AMERICAN TIRE DISTRIBUTERS JSP14-23

Consideration of the request of BC Construction Group LLC for Preliminary Site Plan with a Site Condominium and Stormwater Management Plan approval. The subject property is located on the east side of Regency Drive off of Haggerty Road in the I-1, Light Industrial District. The applicant is proposing to construct a 125,060 square foot industrial building consisting of warehousing and offices in the Regency Industrial Centre.

PLAN REVIEW CENTER REPORT

SUBJECT: American Tire Distributors, JSP14-0023, Traffic Review of Preliminary Site Plan, PSP14-0073

Site Aerial – Proposed American Tire Distributors

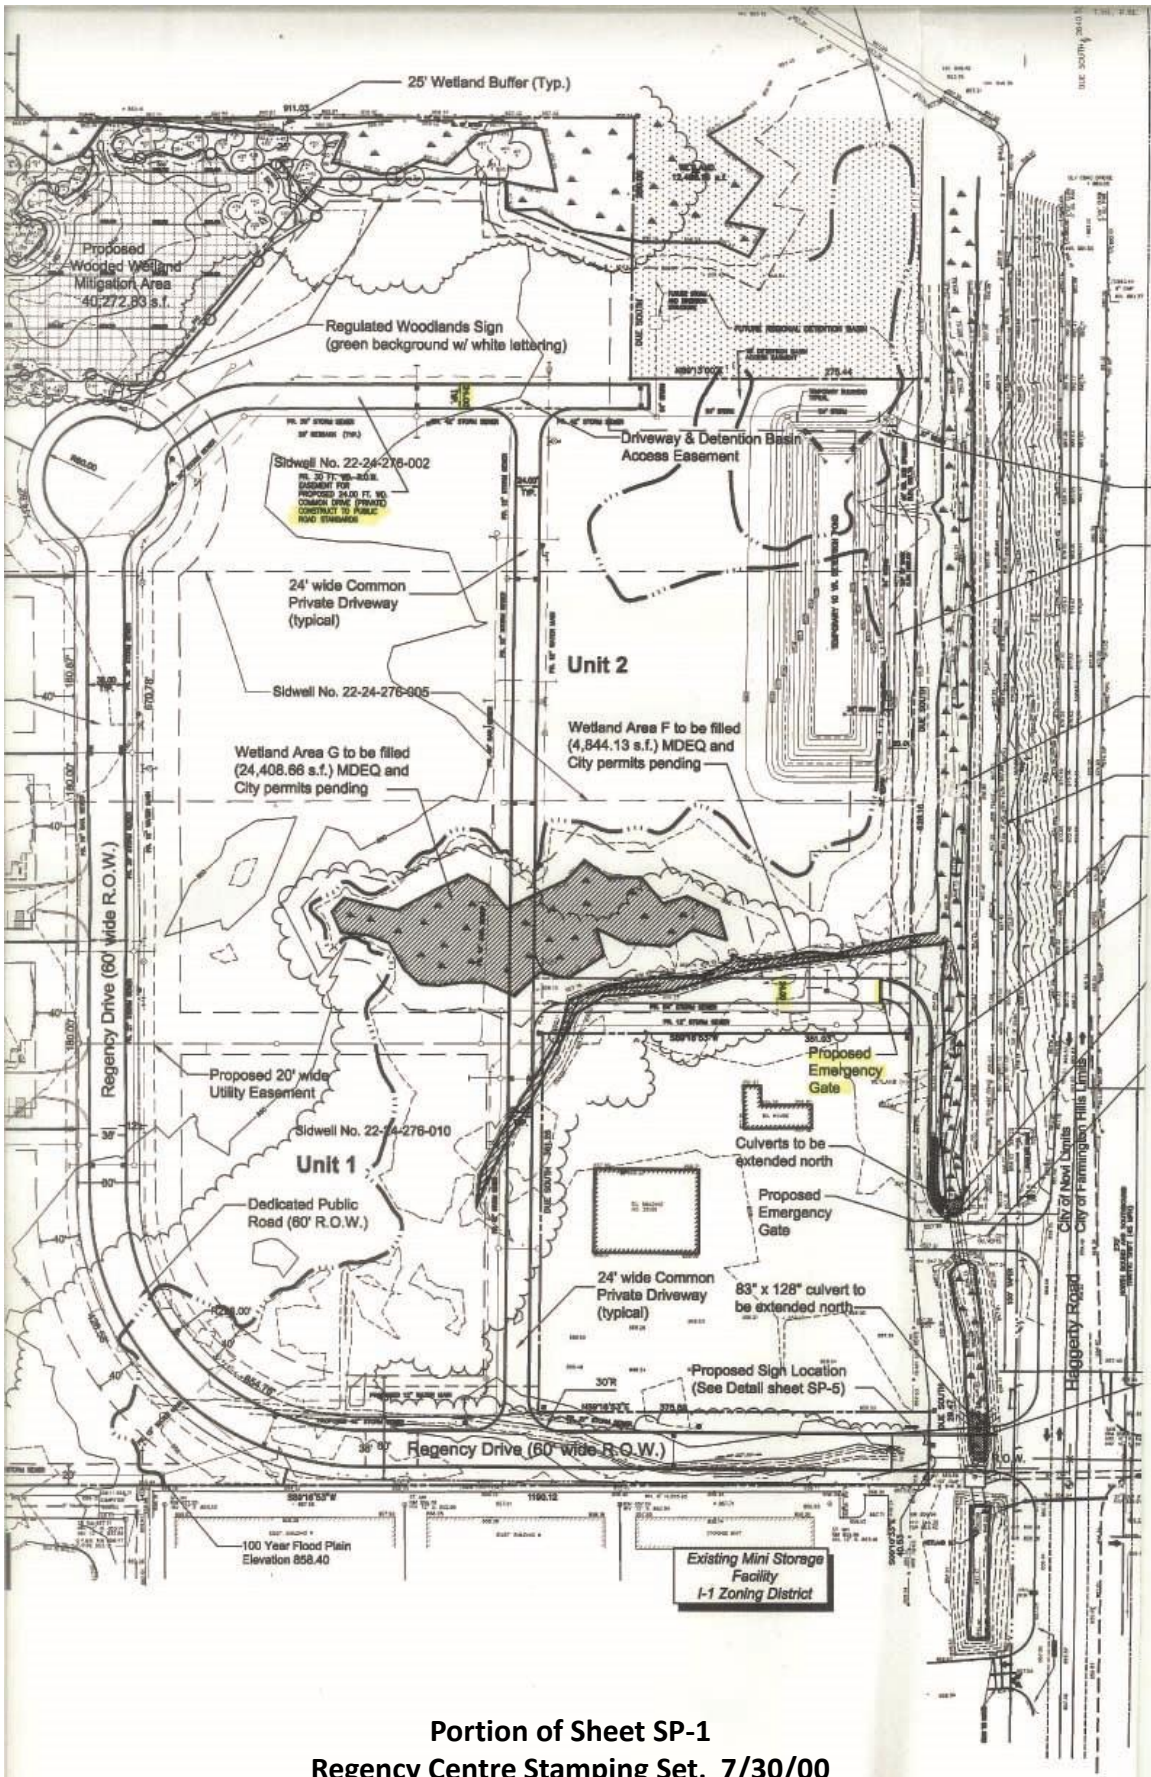
1. The applicant is proposing a 125,060-s.f. tire warehouse on Regency Drive (see attached aerial photo). **The City's Master Plan/Thoroughfare Plan classifies Regency Drive a Local Street; however, we recommend that the City reclassify it a Non-Residential Collector.**
2. We stamped traffic approval of the Regency Centre site condominium on 7-30-00. Several relevant sheets from the stamping set have been attached to this letter for easy reference.

Portion of Sheet SP-1
 Regency Centre Stamping Set, 7/30/00

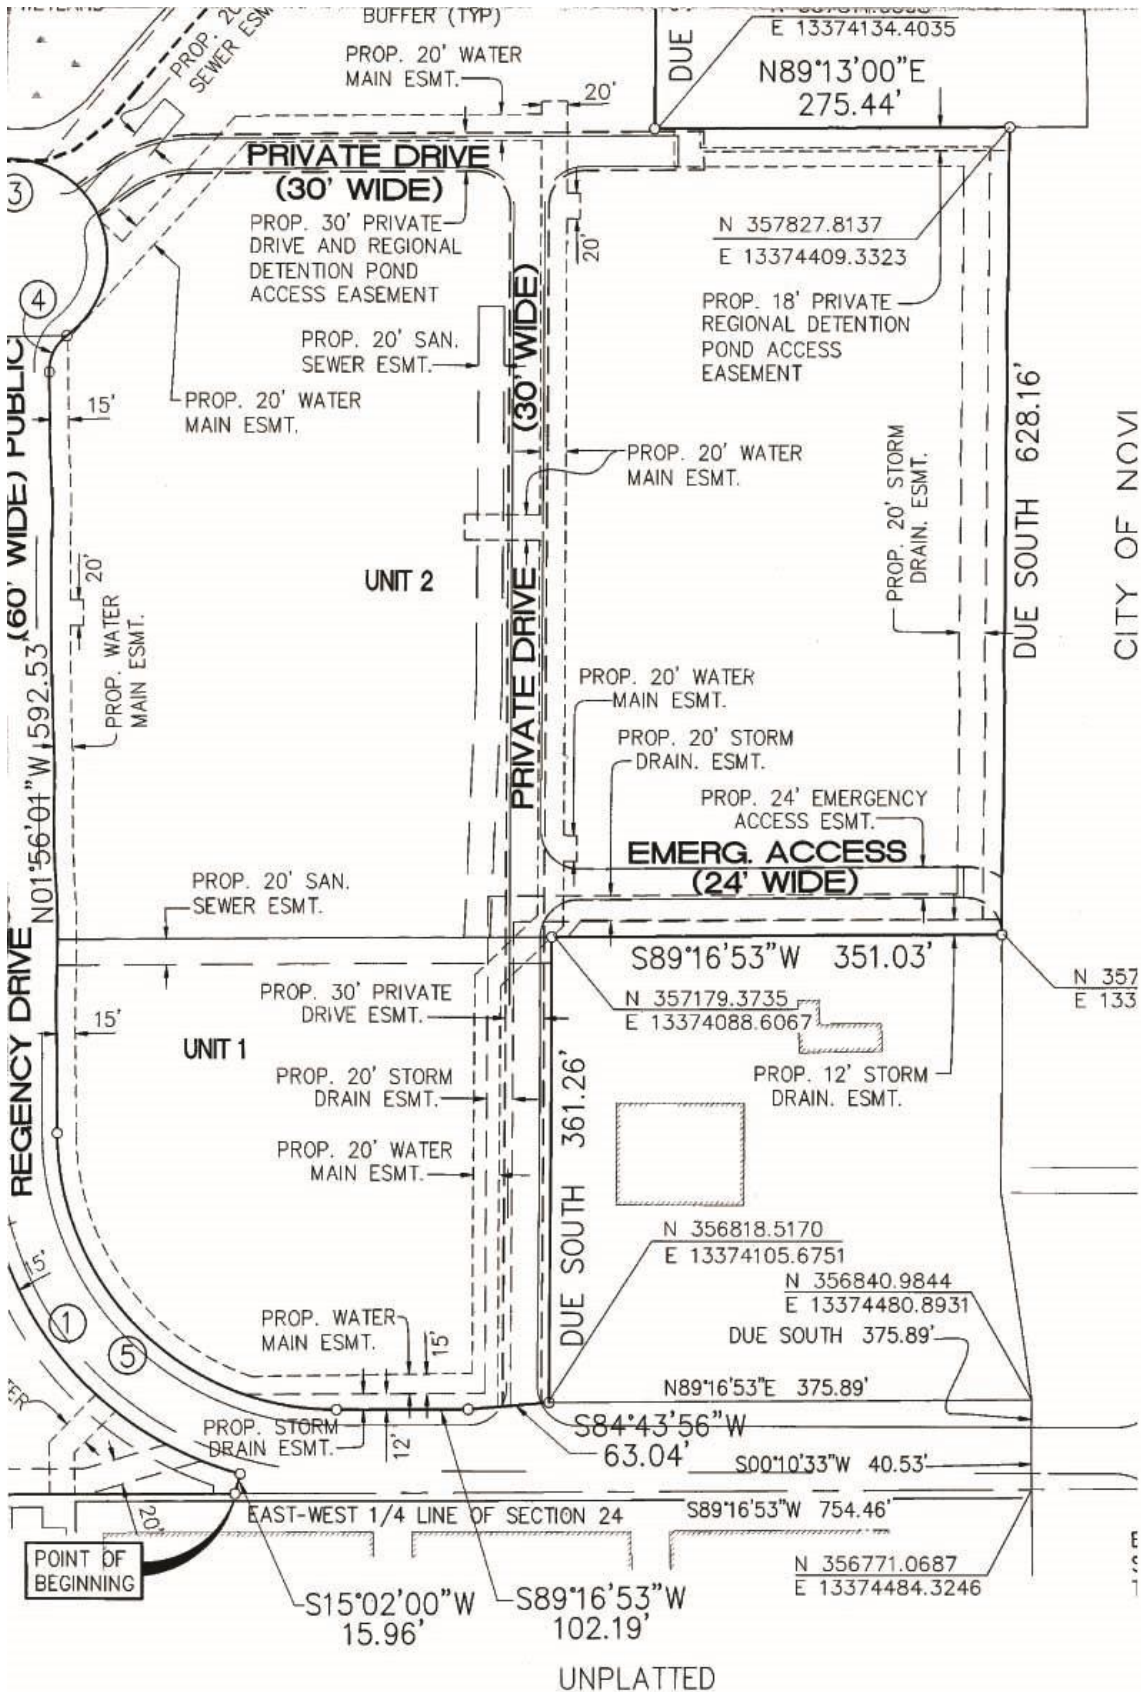
6. Due to the length of the Regency Drive cul-de-sac, the condominium site plan called for a secondary access along Regency approximately 375 ft west of the Haggerty Road right-of-way (see sheet C1A from the approved condo site plan, attached). This secondary route included a pre-existing driveway serving a now-demolished building on Haggerty just north of Regency Drive and an 18-ft-wide service drive parallel to Haggerty, both paved. As also shown on attached sheet C13A, there was to be a City-standard gate at the north end of the service drive, accompanied by an advance sign advising that the drive was for “Emergency Access Only.” **We have been advised by the current property owner that the required gate (and presumably the sign as well) were never installed by the previous owner/developer. A City-standard gate (detailed in the City’s Design and Construction Standards, on the second page of Fig VIII-K) should be installed prior to occupancy of the subject site.**

Table 10-4. Loading Space Dimensions

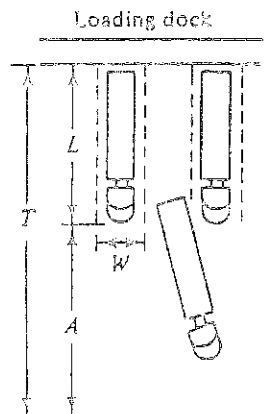
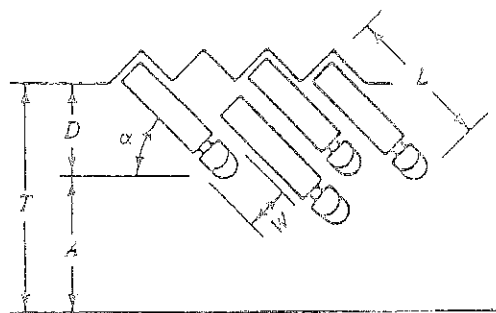
14. As we noted in our pre-application comments, “The plan proposes that the loading-dock apron and associated maneuvering area be a total of 130 ft wide. Individual berths are effectively 13.5 ft wide. For this berth width, ITE (per attached table) recommends a total paved area 119 ft wide for WB-50 tractor-trailers and 145 ft wide for WB-67 tractor-trailers (inferred by us by adding 5 ft to an interpolated table value of 140 ft for a WB-62). To support the proposed design, the preliminary site plan should indicate the appropriate largest design vehicle, and then show (again using AutoTurn or an equivalent software) how that vehicle would maneuver into and out of a berth.” A WB-50 has now been shown pulling away from one of the docks. **The applicant should explicitly confirm that there is no expectation of having to accommodate any trucks larger than a WB-50. We have attached to this letter our mark-up of the site plan, confirming that a WB-67 would require several additional feet of lot width.** For the record, we recently saw evidence that a WB-67 had served the Novi Wal-Mart (it has a 53-ft-long trailer).

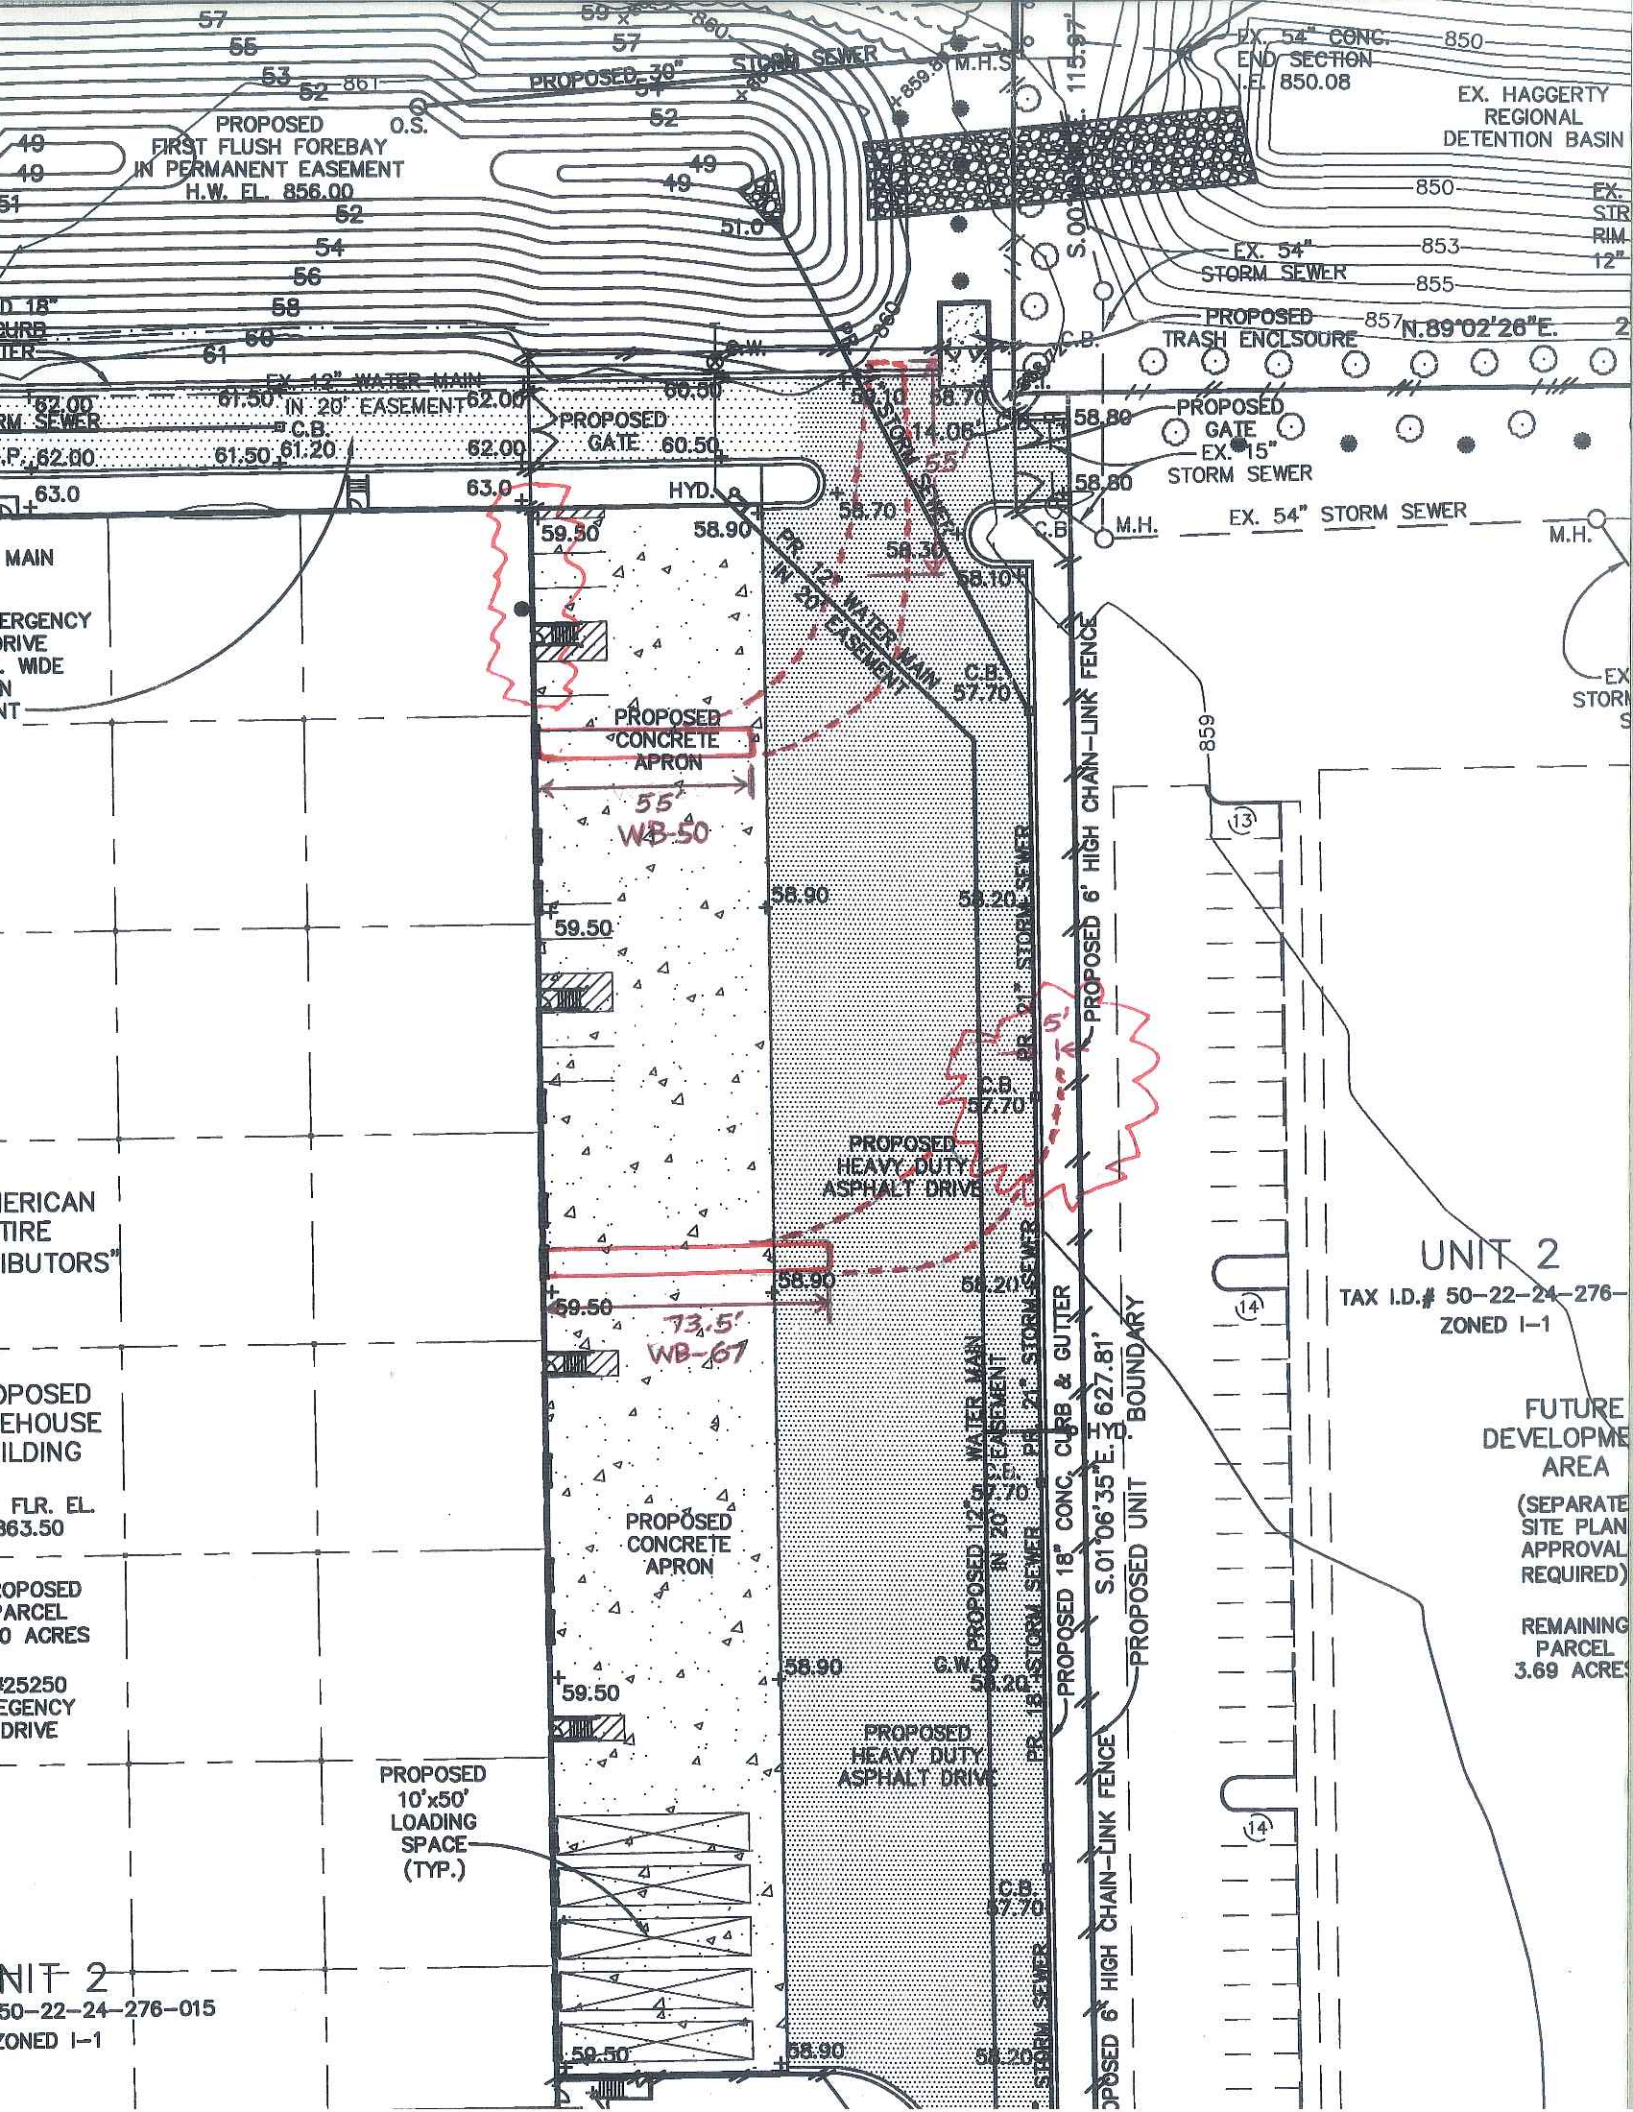
15. Our mark-up also shows a WB-50 pulling as far north in the lot as possible and then backing to the northernmost accessible dock, which would be about 54 ft south of the building’s north end. Consistent with this finding, we note that building elevation sheet A3.1 shows a service door and three potential docks in that distance, the latter via dashed lines and labels reading “K.O.” (presumably standing for “Knock Out”). **Since those three potential docks would not be reasonably accessible by large trucks, we suggest that they either be deleted or revised to become grade-level overhead doors usable only by smaller service vehicles.**
